**AIP SUPPLEMENT
(SUP)****AIRAC****H173/25****Effective: 202511261600 UTC**

WILKINS RUNWAY (YWKS) REVISED PROCEDURES

- 1.1 This AIP SUP amends the RNP RWY 09T Instrument Approach Procedure and aerodrome chart at Wilkins Runway due to apron and runway data changes.
- 1.2 New RNP APCH waypoints have been designed, to ensure continued alignment with the new RWY position.

AERODROME CHART
WILKINS RUNWAY, ANTARCTICA (YWKS)

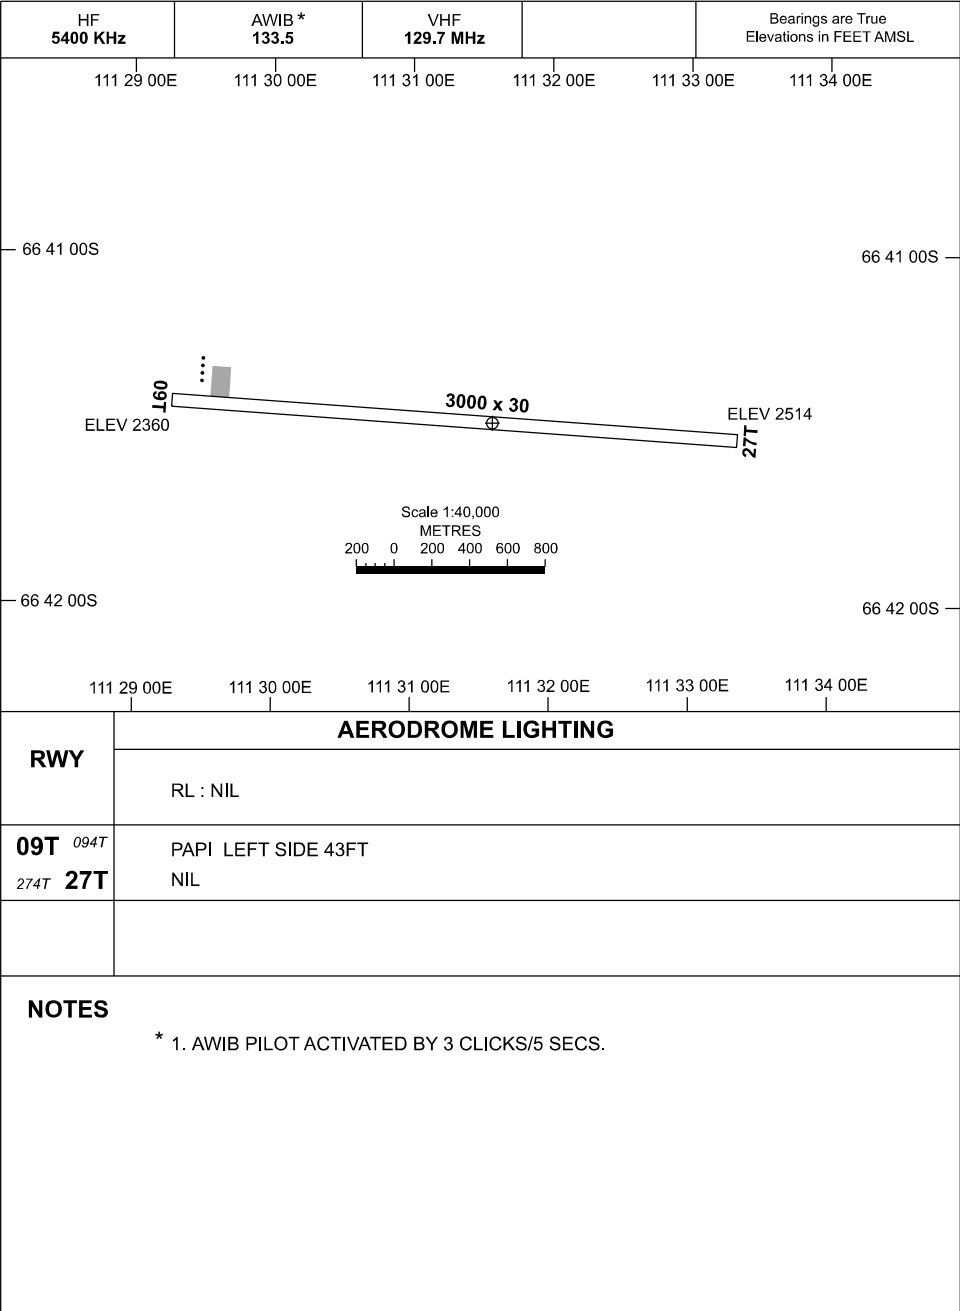
3.1 Amended aerodrome data:

ARP/Threshold	Latitude	Longitude	Elevation
ARP/AD ELEV	664129.02S	1113134.86E	2522 FT
RWY 09T	664125.46S	1112916.55E	2360 FT
RWY 27T	664131.72S	1113320.64E	2514 FT

RNP RWY 09T

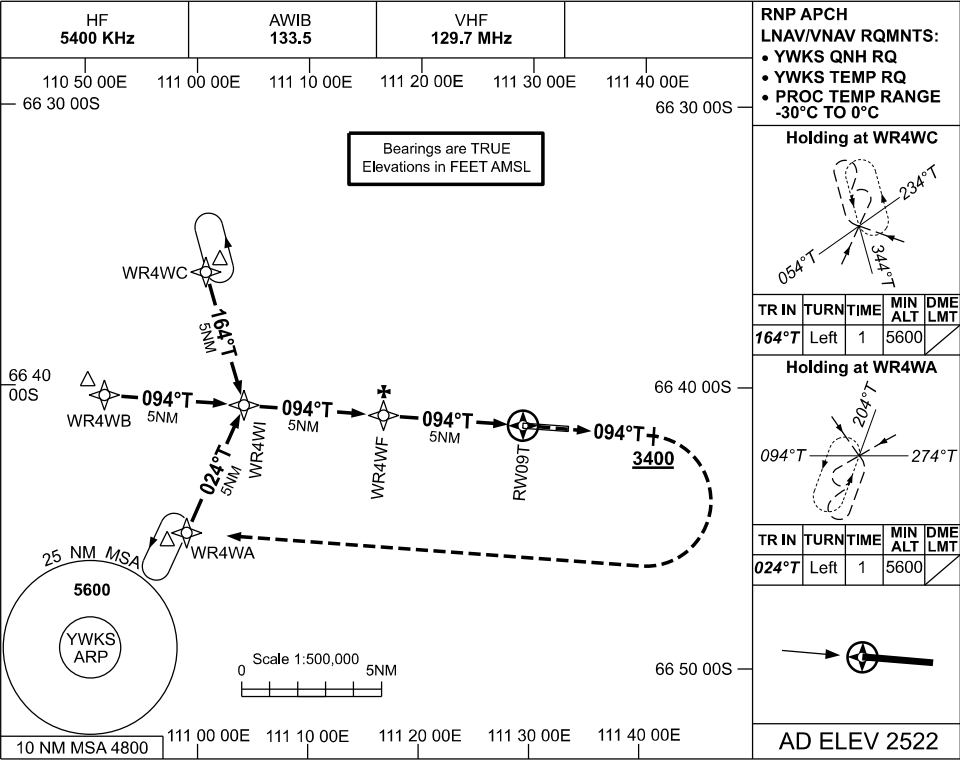
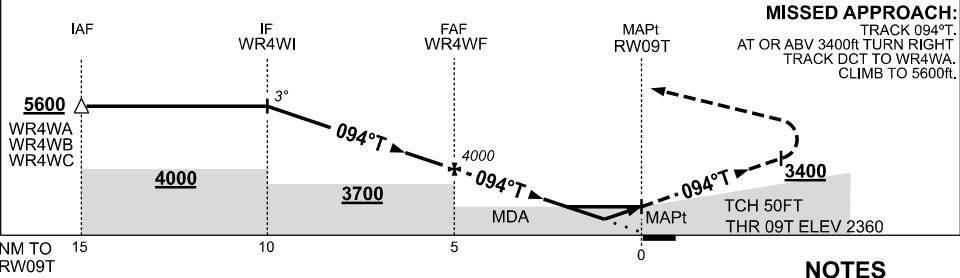
- 2.1 New waypoints for the amended RNP RWY 09T:

Name	LAT	LONG
WR4WA	664517.23S	1105901.92E
WR4WB	664022.50S	1105138.97E
WR4WC	663559.92S	1110045.43E
WR4WI	664044.48S	1110411.14E
WR4WF	664105.47S	1111643.67E

- 2.2 The following waypoints are no longer in use from the effective date of this SUP: WR3WA, WR3WB, WR3WC, WR3WI, WR3WF.
- 2.3 Recommended coding is available on request.

Changes: REVISED PROC, AD ELEV, THR ELEV.
